An Independent Technical Review – Comments on Flood Frequency Analyses for the Skagit River, Skagit County, Washington

Our Project No. 10353

Prepared by
Theodore V. Hromadka, II
Ph.D., Ph.D., Ph.D., P.E., P.H.
Licensed Geoscientist
Principal

June 7, 2007

Figure 1: November 1995 Flow Hydrographs at Skagit River near Concrete and at Sedro Woolley

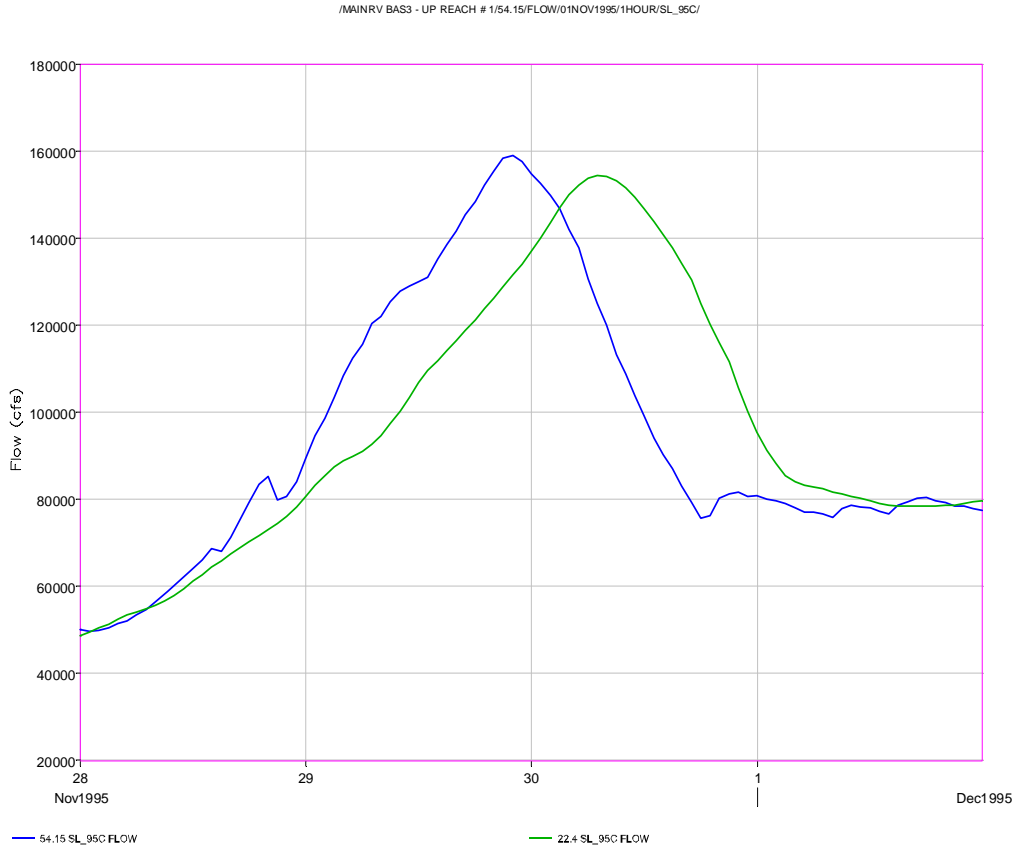
Figure 1 and 2 show flood hydrographs at Concrete and Sedro-Woolley and the HEC-RAS model results showing very little attenuation effects (less than 1%) between Concrete and Sedro-Woolley whether flashy (2003 flood) or voluminous (1995 flood) hydrographs were assumed for the 4 unrecorded events.
